FVA industry sub-group on technical requirements

15.11.2022

Summary for goals & next steps (1/2)

Area S vs. V2 point vs virtual image distance

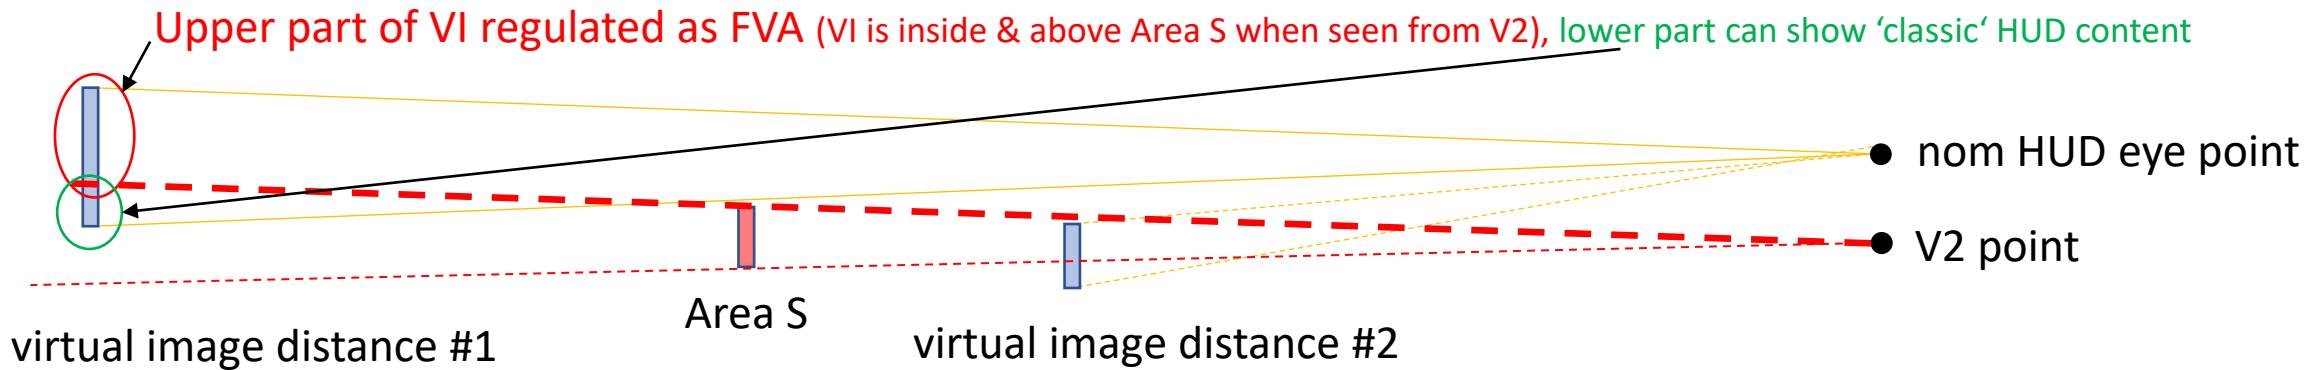
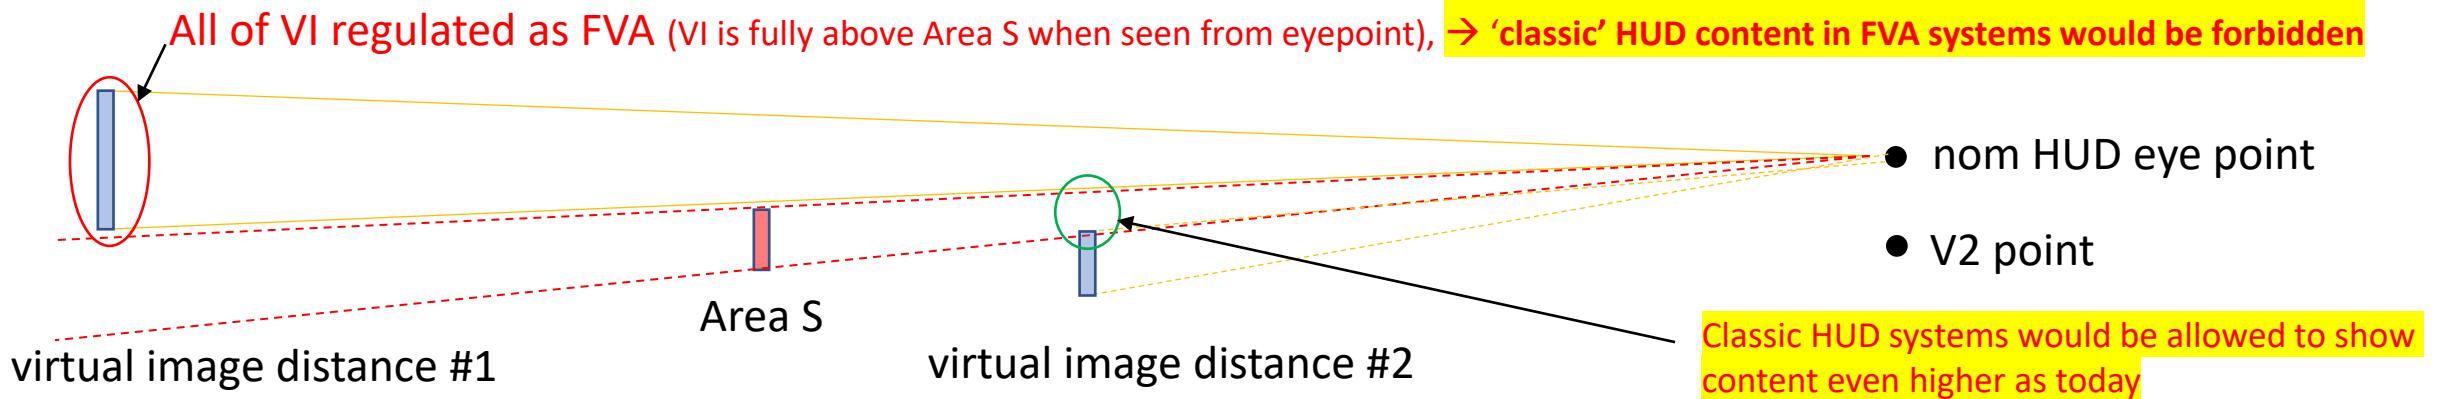
FVA systems typically have a larger VID and less lookdown angle (LD is about -2.5° instead of about -5° for classic HUD systems)

CASE 3: large VID, less LD angle (typical FVA system), investigated from V2 point (current regulation)

CASE 4: large VID, less LD angle (typical FVA system), but investigated from eyepoint instead of V2

Conclusion: Keep the requirement to calculate from V2 point (as currently defined), considering that the parallax error will happen for any object that is not exactly in the same plane (i.e. same distance) as Area S.

Conclusion as of 15.11.2022: keep as currently (defined from V2 point)
If it does not work similarly for other vehicle categories, a common solution should
be found and/or the definition may be revised

Figure 1
Definition of E-Points

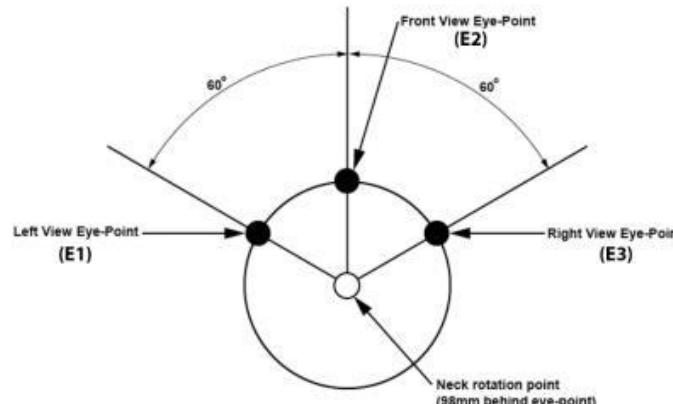
- Suggestion to be checked by truck manufacturers:
- Define an Area S_2 (similar as seen from V2 point), upper edge of that Area S_2 is defined identically as -1° lookdown angle, but lower edge is not limited to -4° . Instead it is extended further down, and of that Area S_2 e.g. 20% max. may be covered (but only accounting for image content and not physical obstruction)
- Refer to new regulation for direct vision [R167]. Eye position is different and defined according E2: definition 2.3 & fig. 1:

→ FVA content may be displayed also above and besides this Area S_2 , just as currently regulated.
